# CITY OF ALBUQUERQUE

RE: **Lot 2, Block 2, Unit 19 S.A.D. 228**  
**7831 Aguila St NW**  
**Grading and Drainage Plan**  
**Engineers Stamp Date 6/26/19 (D10D003G2)**

## DRAINAGE AND TRANSPORTATION INFORMATION SHEET (REV 6/2018)

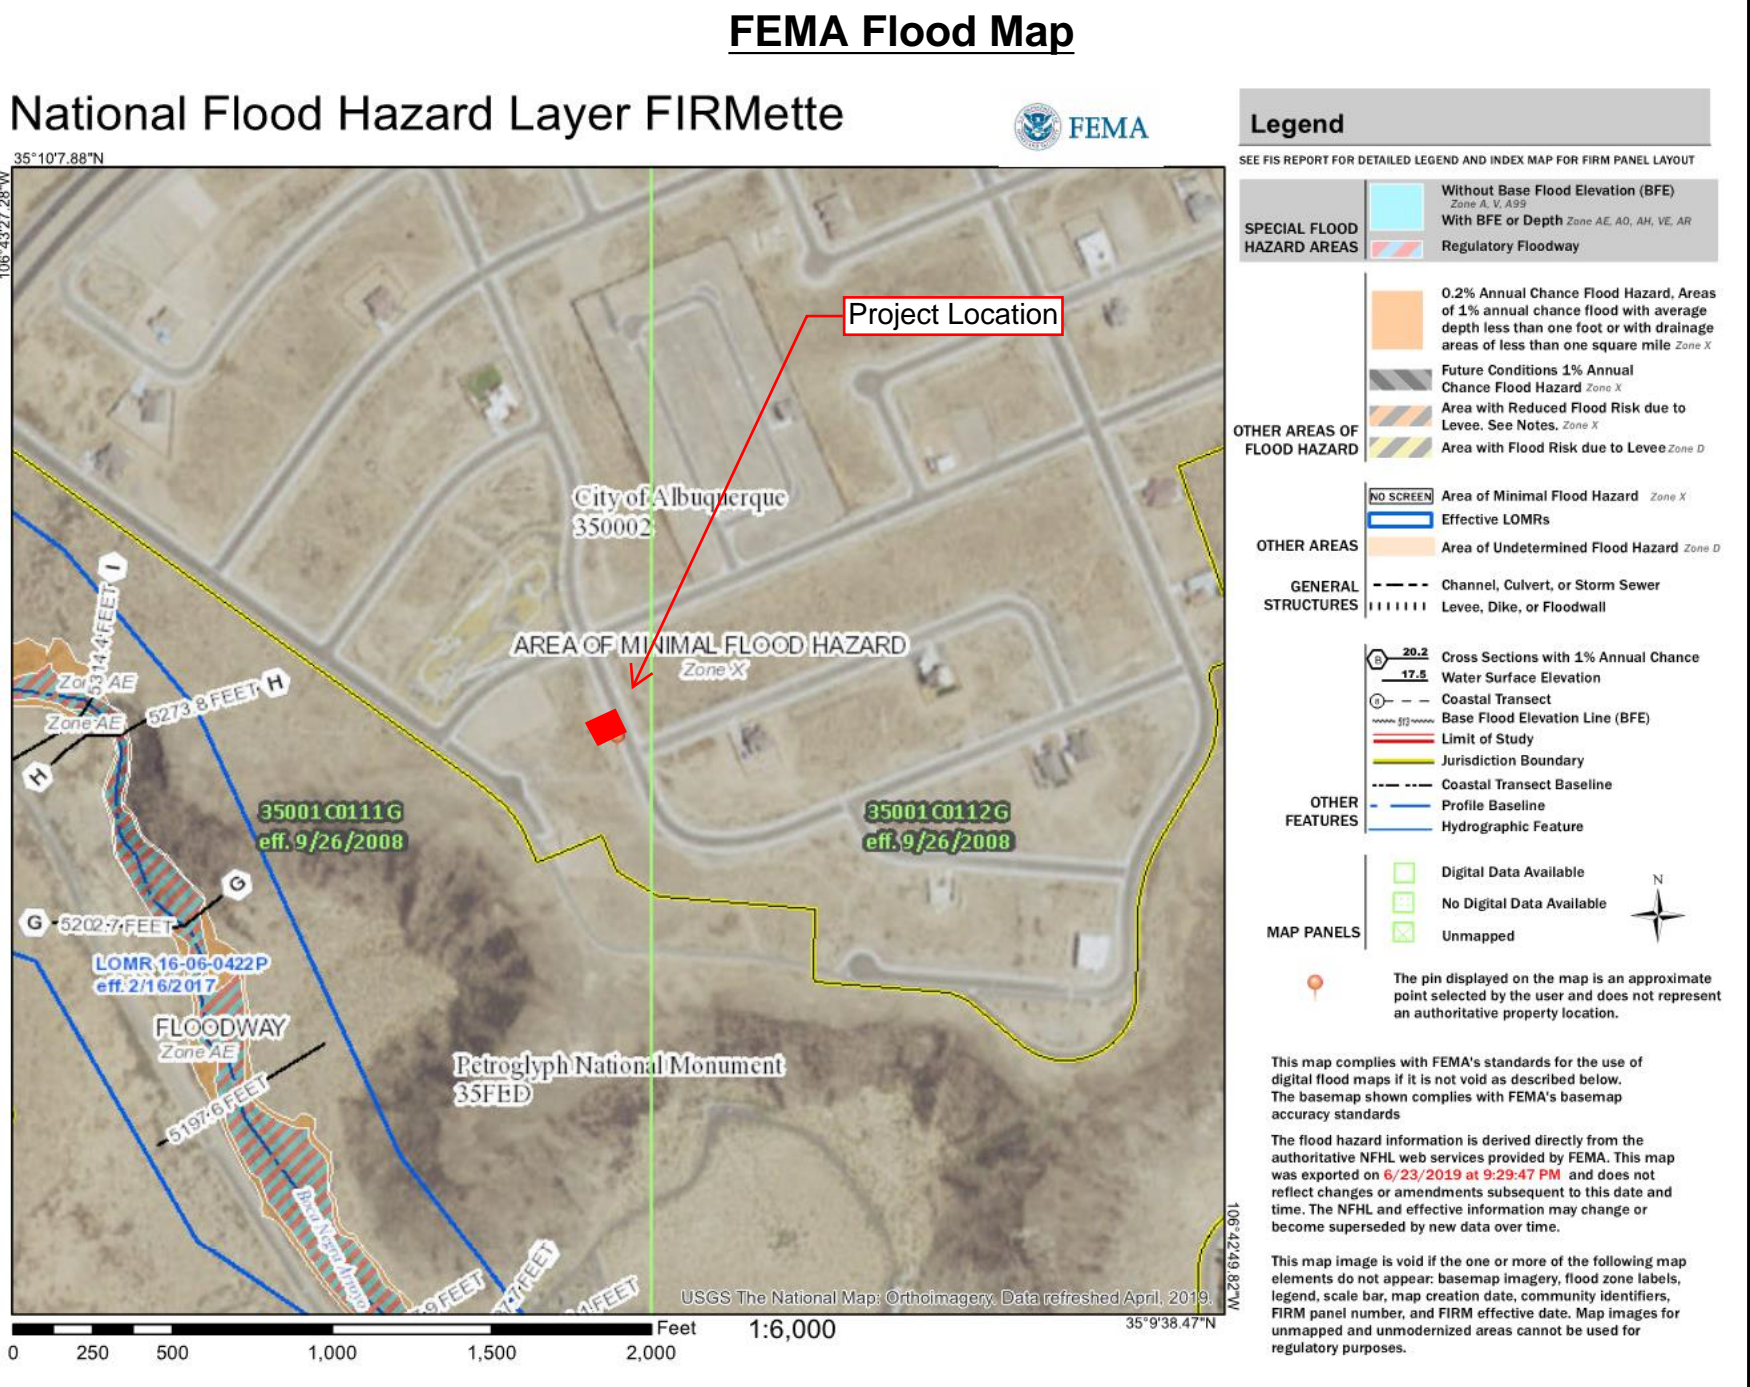
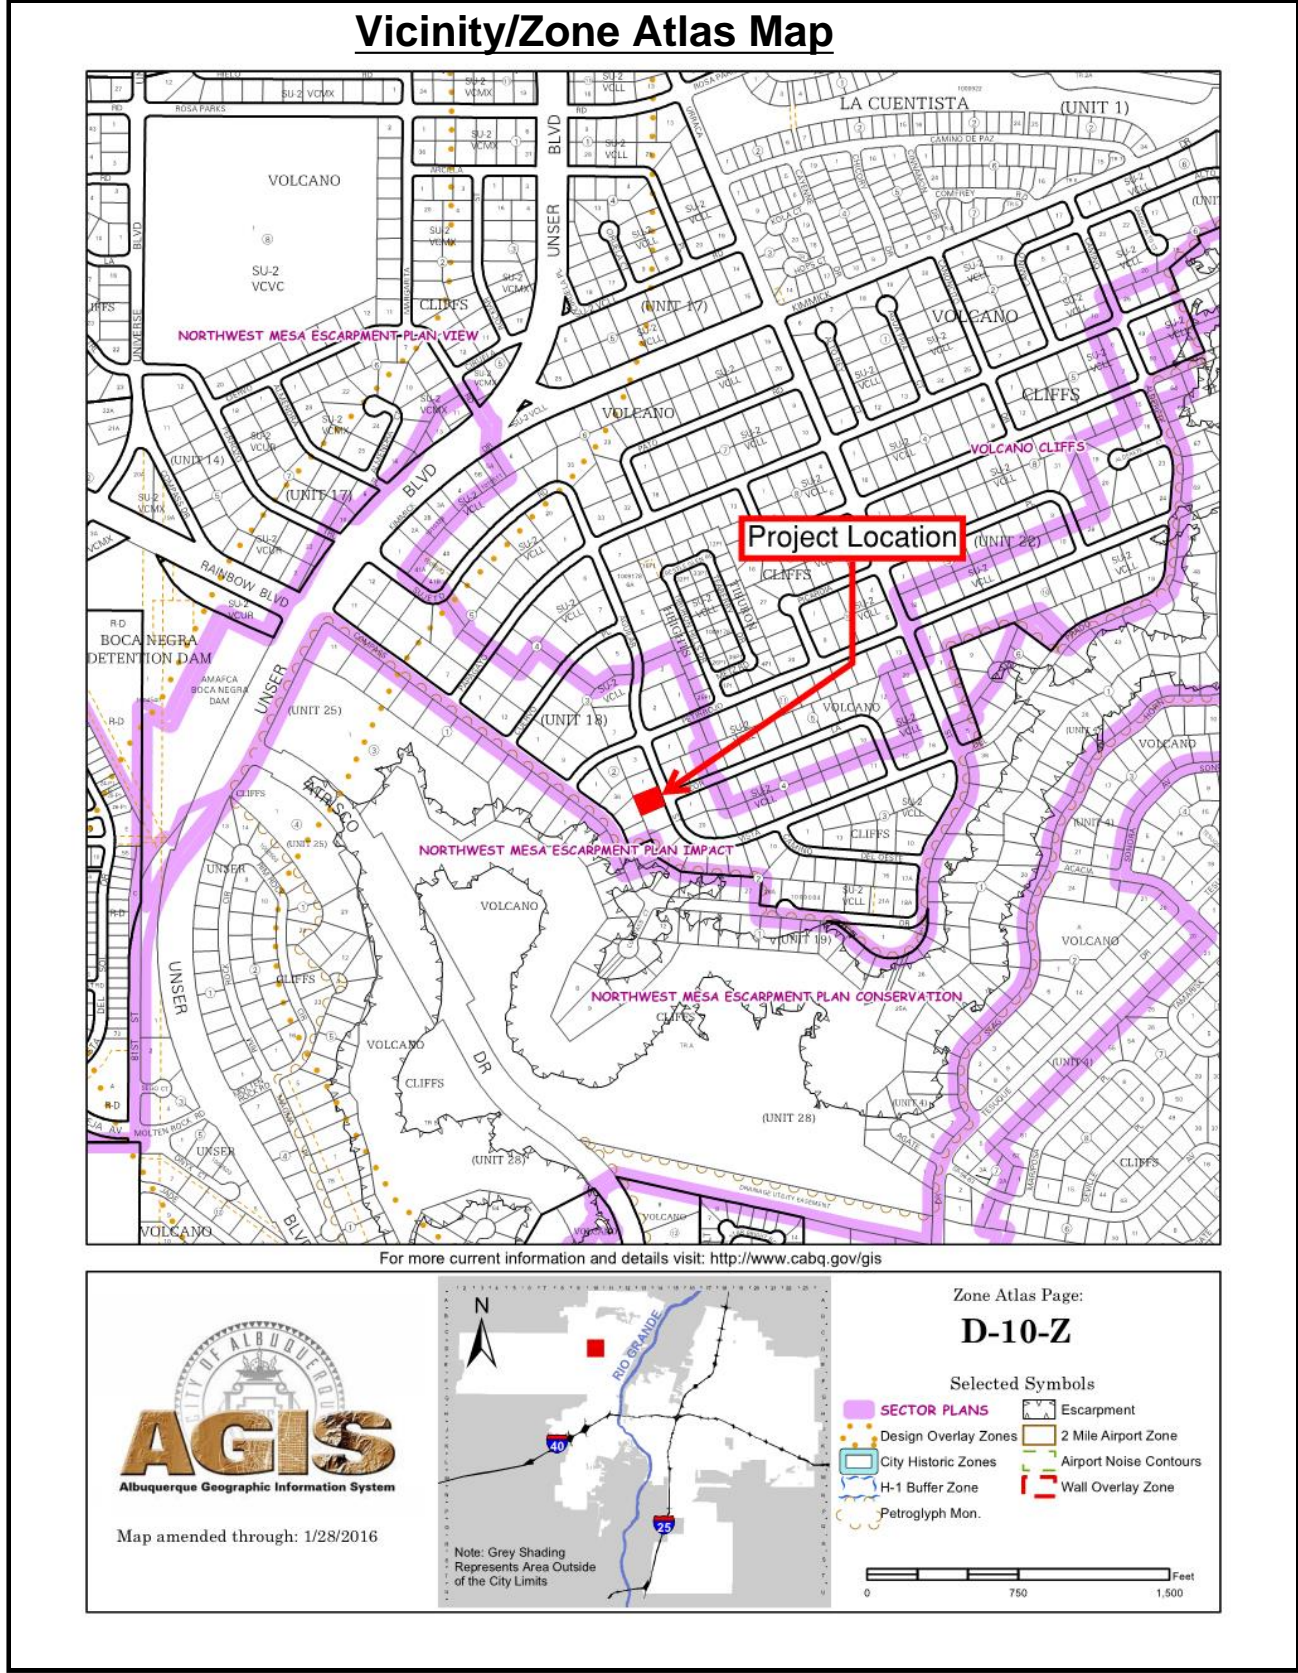
Based upon the information provided in your submittal received 6/28/19, this plan is approved for Grading Permit.

**A pad certification is required before concrete is poured, either by a letter from you stating that the pad is built according to the plan submitted or by an as-built with elevations plotted.**

Also, please advise the owner/contractor that a separate wall permit must be obtained and this approved grading plan dated 6/26/19 must be provided with the wall permit application.

Prior to Certificate of Occupancy release, Engineer Certification per the DPM checklist will be required.
